FOUNDATION LUTHERAN CHURCH SUBDIVISION FILING NO. 1

SUBDIVISION PLAT
FOUNDATION LUTHERAN CHURCH
SUBDIVISION FILING NO. 1

Letter of Intent for Final Plat

SUBSURFACE SOIL INVESTIGATION

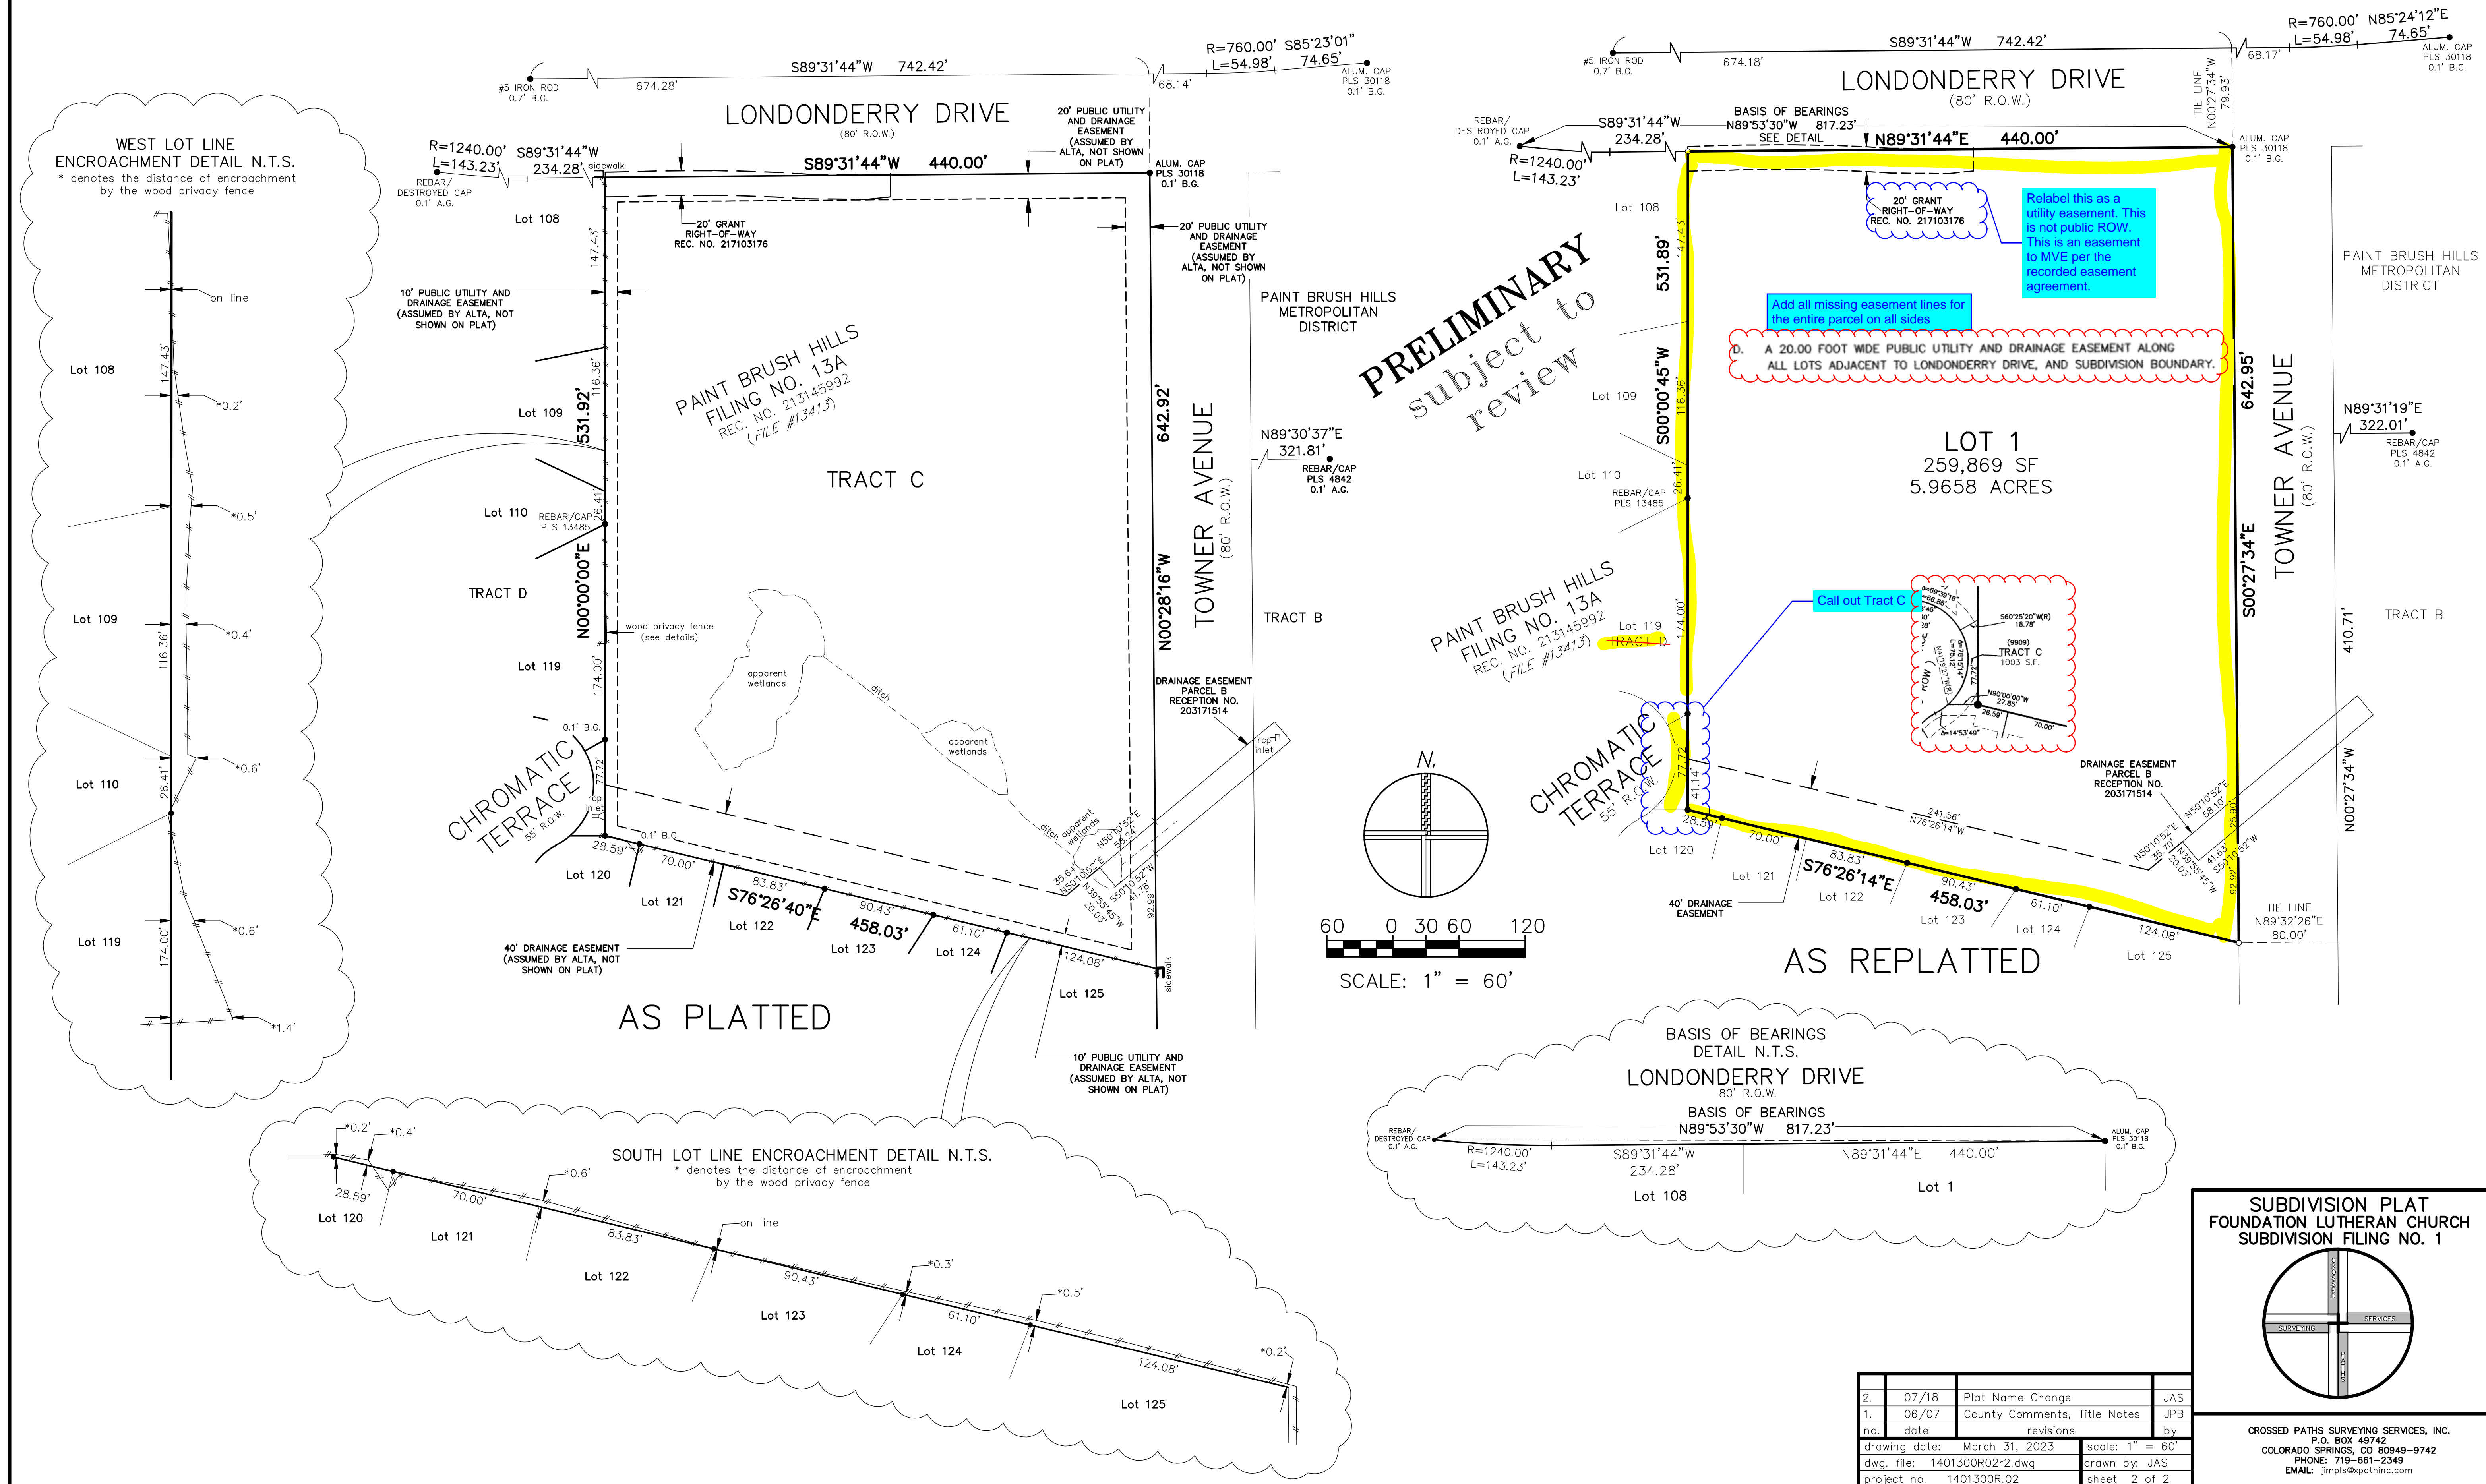
Add Missing Notes

Plat is missing considerable plat notes to include applicable notes from Plat 13413.

Add PCD File #SF2321

SUBDIVISION PLAT
FOUNDATION LUTHERAN CHURCH
SUBDIVISION FILING NO. 1

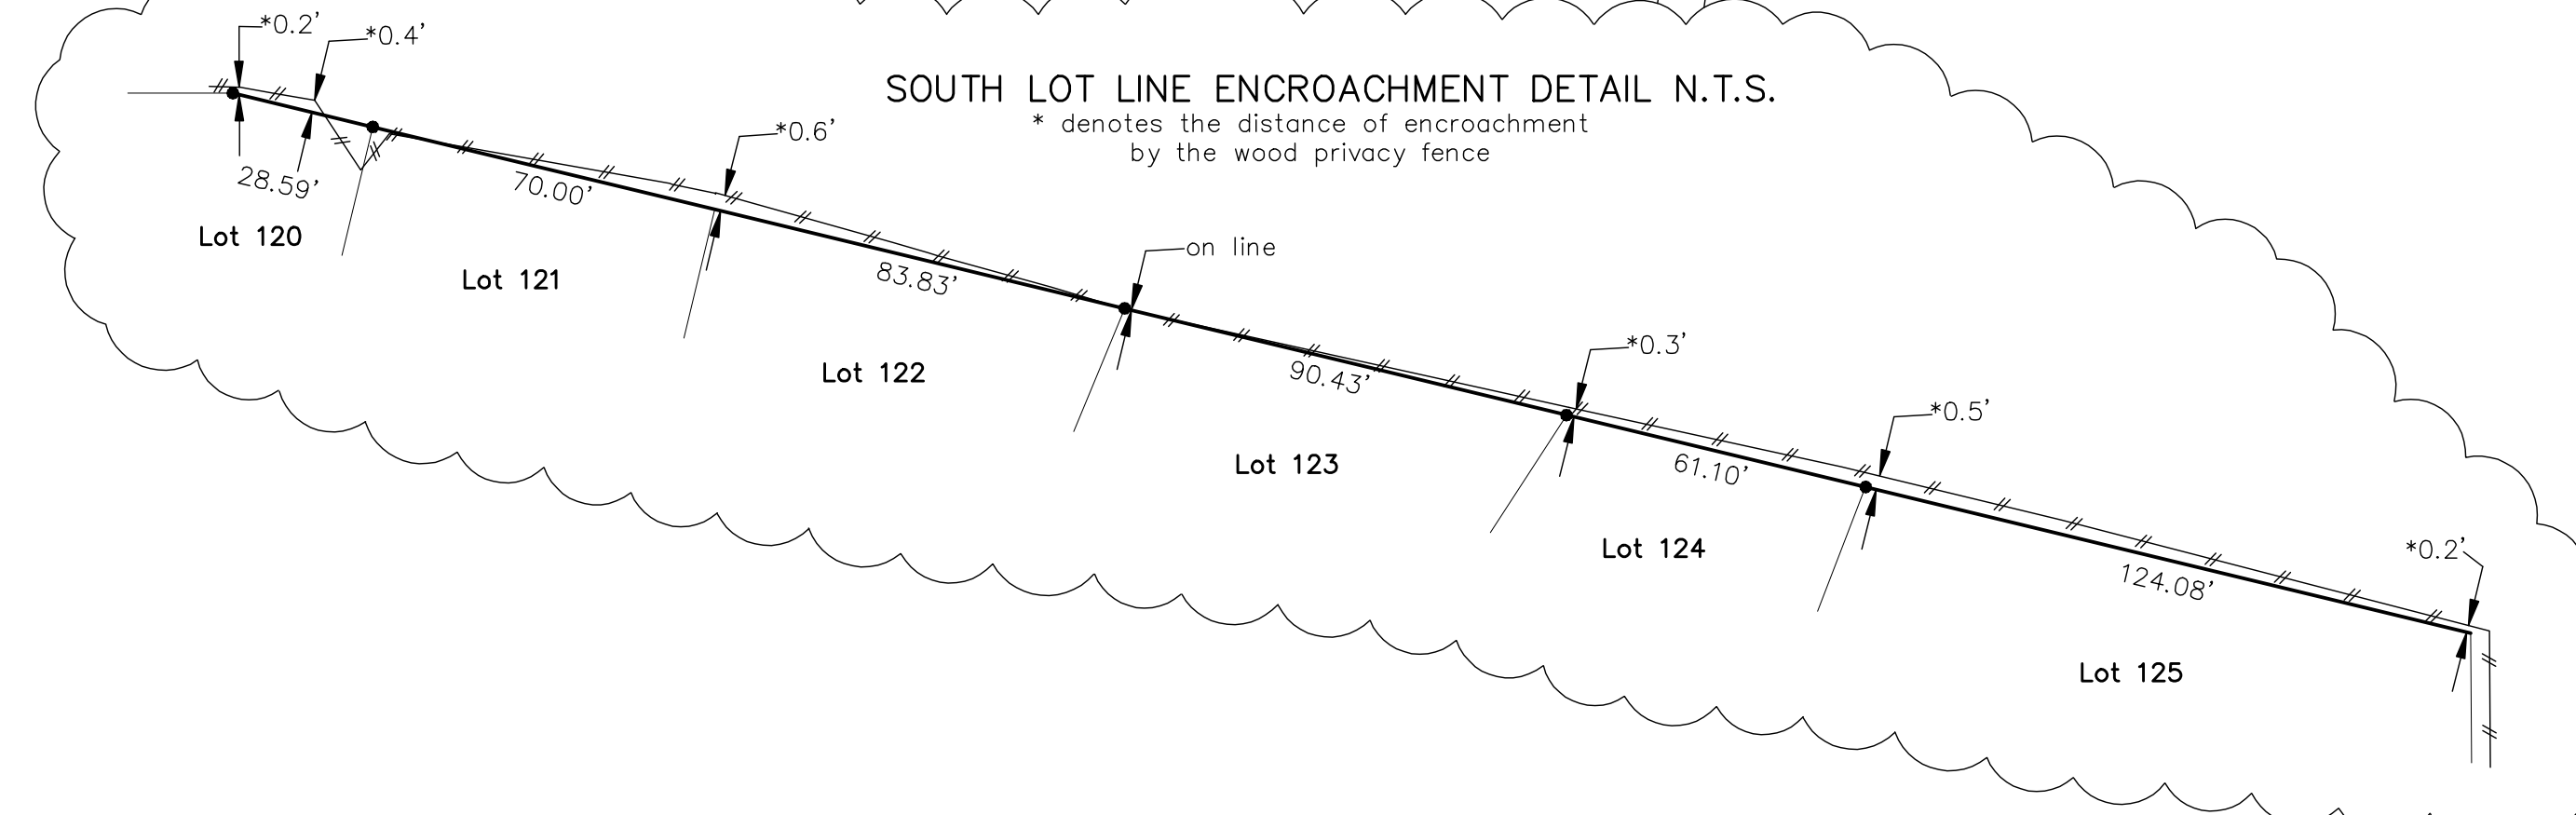
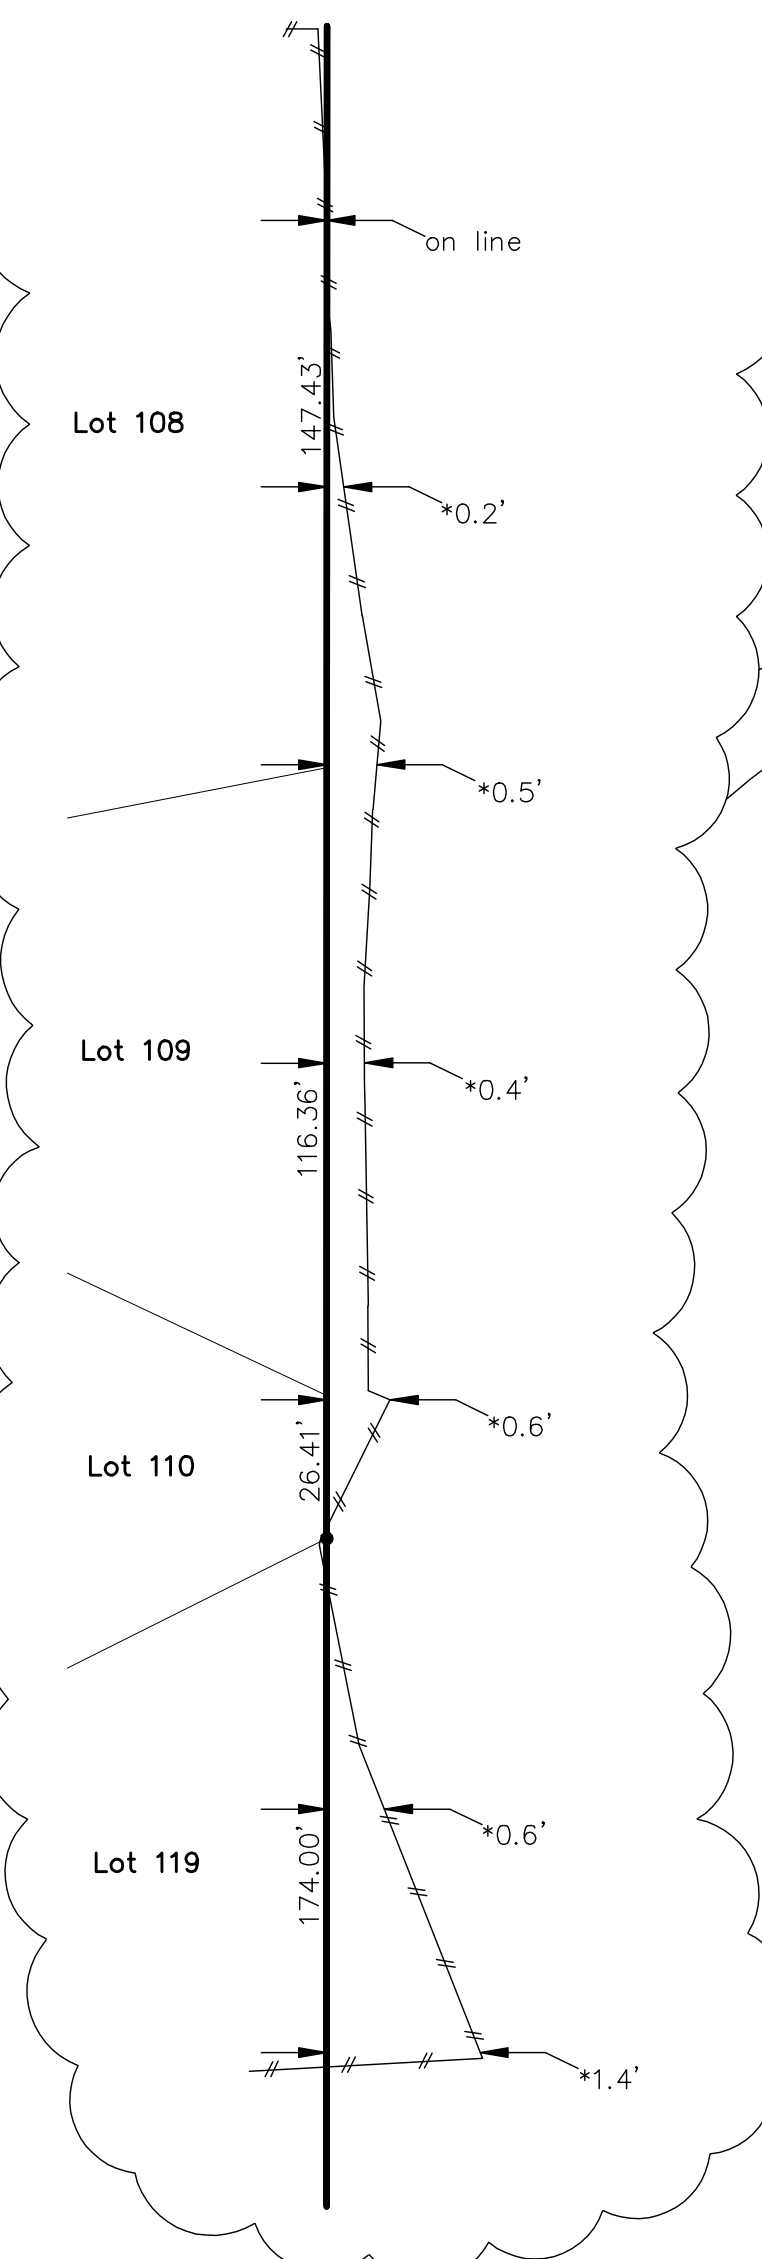
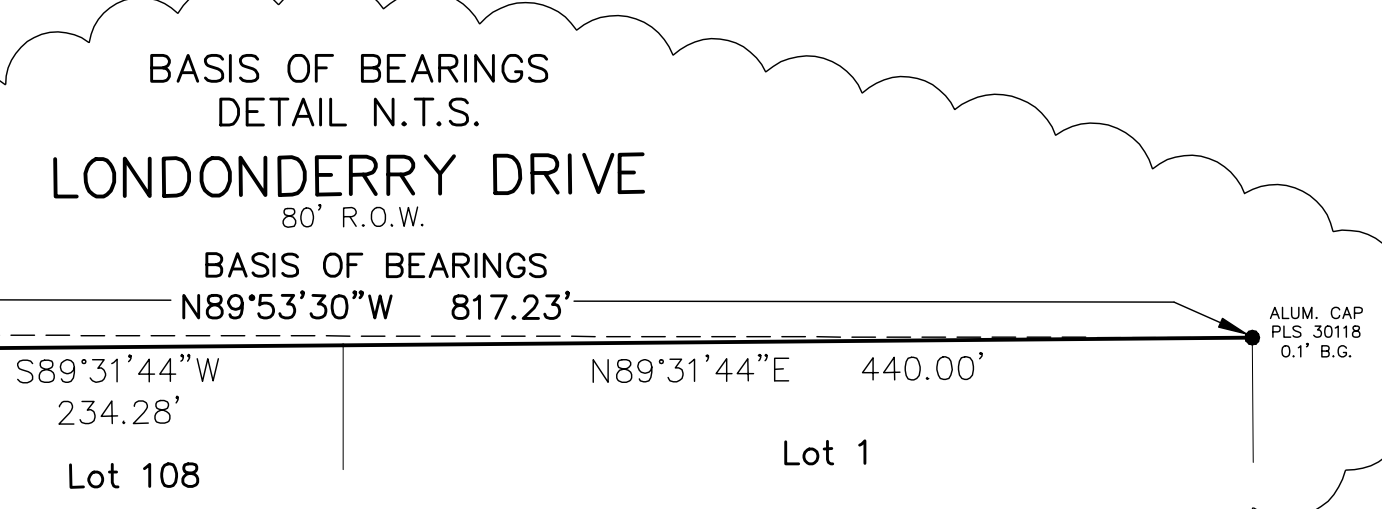
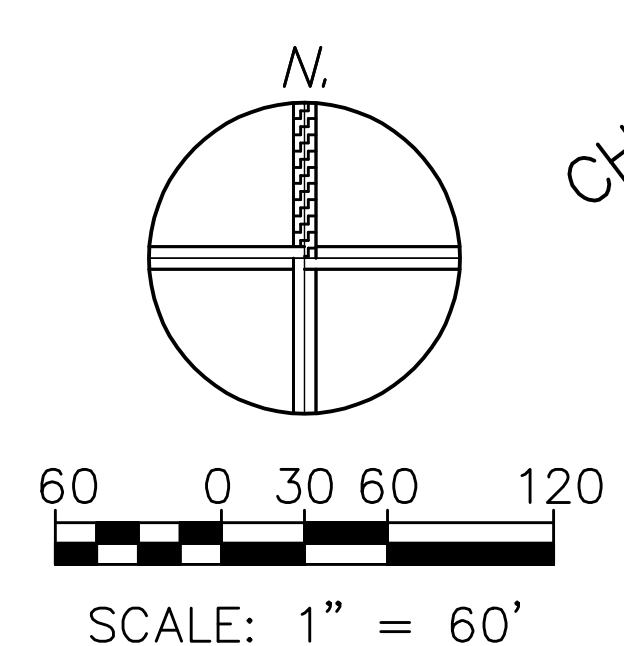
Relabel this as a utility easement. This is not public ROW. This is an easement to MVE per the recorded easement agreement.

Add all missing easement lines for the entire parcel on all sides
